WHITESTONE SOLAR FARM

5.1 Consultation Report Appendix G Targeted Consultation

Application Document ref. EN0110020/APP/5.1
Revision 01
June 2026

Targeted Consultation Leaflet

Change 1: Cable Route West of Micklebring

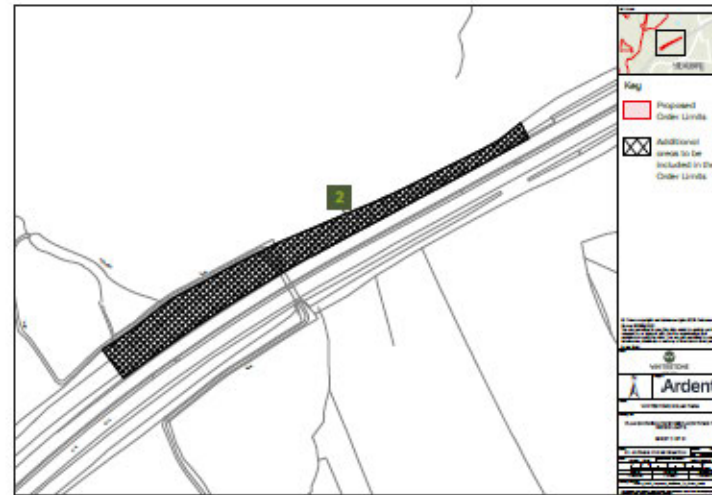
Description of Change: Additional land west of Micklebring and the M18 is under consideration as an alternative cable route option for Cable Route B to avoid cabling to the east of Micklebring Gorse, pending finalisation of environmental and engineering surveys on both locations. This does not add an additional cable route but provides an alternative option for the already proposed cable route between Whitestone 1 and 2.

Impact of Change: This change is not anticipated to result in any impacts that are not already being considered within the EIA being undertaken to support the Proposed Development. This change may cause temporary impacts on Public Rights of Way (Conisbrough Parks 4 and 15). The Applicant will seek to ensure access is maintained and any disturbance is short term. Any noise generated during construction of the cable corridor is already being assessed in the EIA and industry best practice mitigation will minimise any short-term disturbance on nearby receptors. Construction work will be managed in a way to minimise any disturbance on receptors through an Outline Public Rights of Way Management Plan and an Outline Construction Environmental Management Plan. This change is unlikely to lead to significant adverse effects.

Changes 5a and 5b

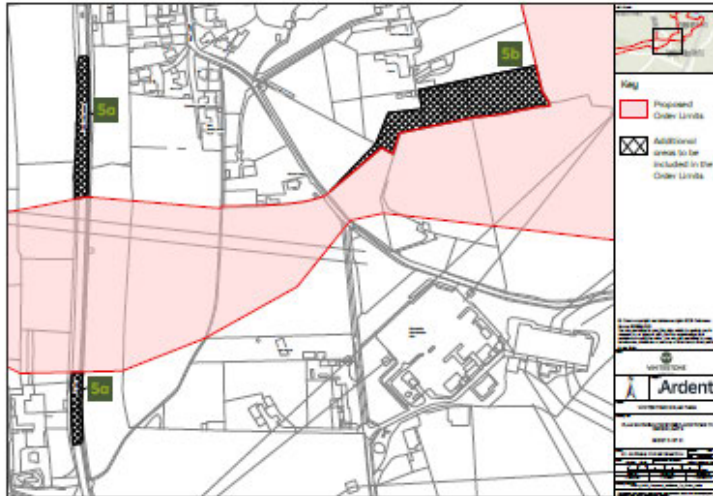
Description of Change: Additional land is proposed along Morthen Lane to allow the proposed access to Cable Route C, to comply with highway safety standards for visibility and temporary speed limits during construction if required. The works could include trimming hedges or roadside vegetation for safe visibility, temporary road signage for managing safe access and temporary speed limits during construction.

Description of Change: Additional land north of Moat Lane is proposed to provide flexibility for Cable Route C construction if the cable route is unable to avoid other proposed developments in the area.

Change 14c: Cable Route South of Upper Whiston

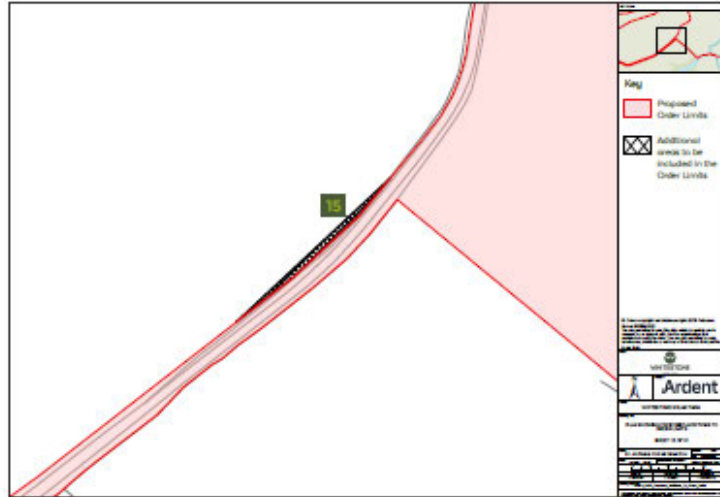
Description of Change: This area of the Cable Route F has been reduced to the southern boundary to avoid hedgerow and so increased slightly to the northern boundary to have sufficient flexibility for safe construction of the cable corridor.

Change 15: Road Safety South of Upper Whiston

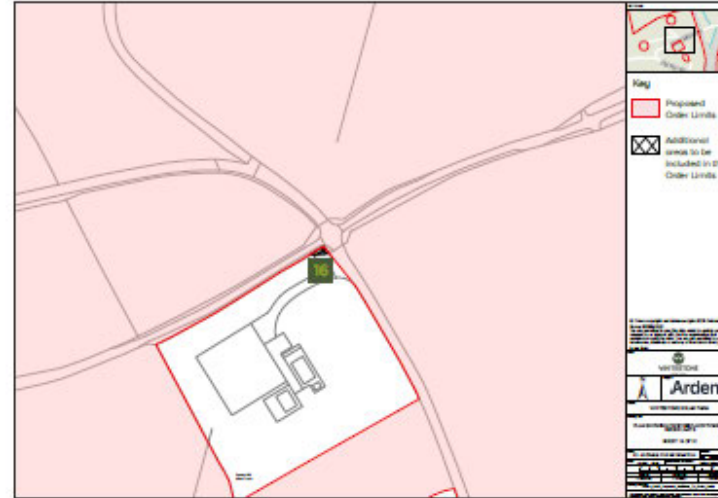
Description of Change: Additional land is proposed along Common Lane south of Upper Whiston to allow the proposed access to the solar area to comply with highway safety standards for visibility and temporary speed limits if required. The works could include trimming hedges or roadside vegetation for safe visibility, temporary road signage for managing safe access and temporary speed limits during construction if required.

Changes 19a and 19b

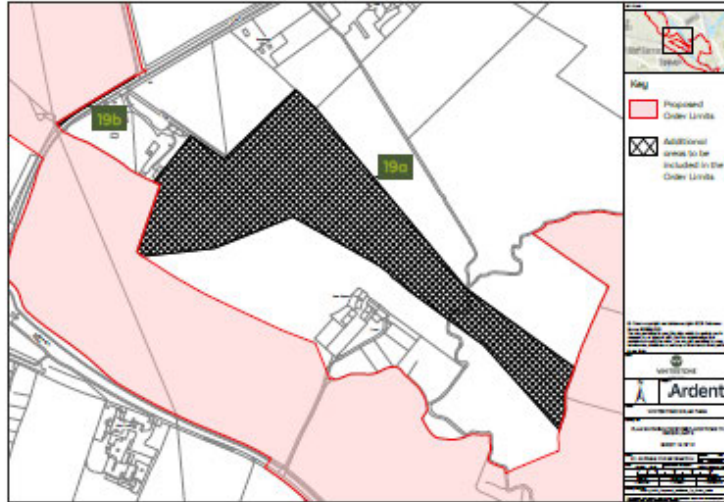
Description of Change: Additional land is proposed north of the A57 and west of North Anston to provide for an alternative cable route option to Cable Route K-2 in response to consultation feedback from the landowner. This alternative could be used instead of, not in addition to, Cable Route K-2.

Description of Change: Additional land is proposed along Todwick Road to allow the proposed access to solar area and Cable Route J, to comply with highway safety standards for visibility and temporary speed limits if required. The works could include trimming hedges or roadside vegetation for safe visibility, temporary road signage for managing safe access and temporary speed limits during construction if required.

Change 21: Road Safety South of South Anston

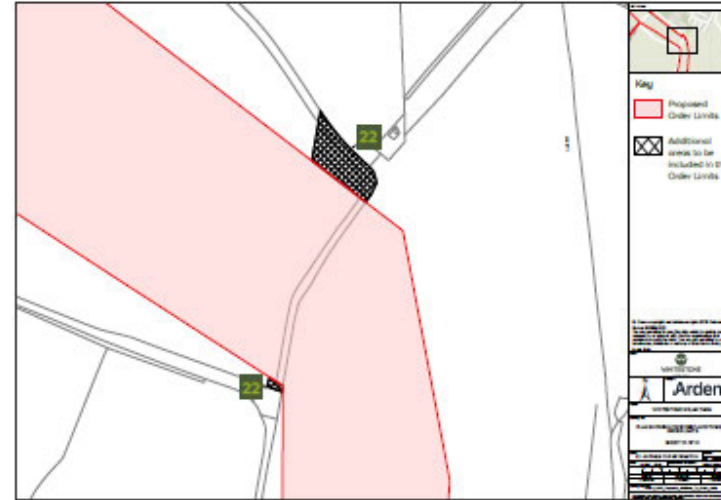
Description of Change: Additional land is proposed along Crowgate and Dog Kennels Hill south of South Anston to allow the proposed access to Cable Route L, to comply with highway safety standards for visibility and temporary speed limits if required. The works could include trimming hedges or roadside vegetation for safe visibility, temporary road signage for managing safe access and temporary speed limits during construction if required.

Change 30: Road Safety East of High Moor

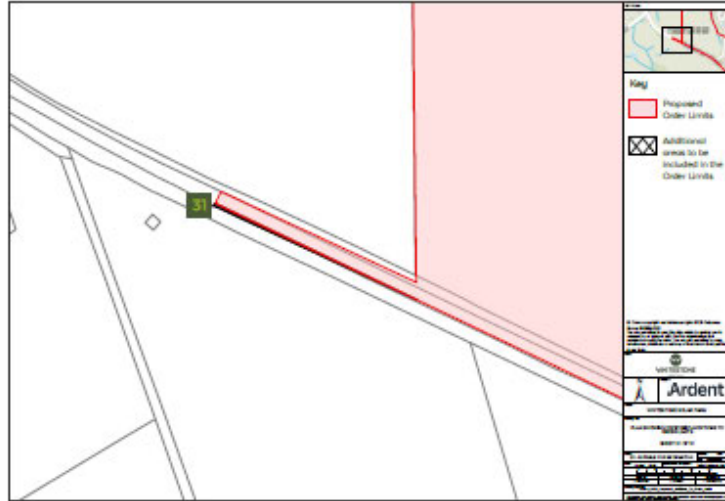
Description of Change: Additional land along Killamarsh Lane is proposed to allow the proposed access to the solar area to comply with highway safety standards for visibility and temporary speed limits if required. The works could include trimming hedges or roadside vegetation for safe visibility, temporary road signage for managing safe access and temporary speed limits during construction if required.
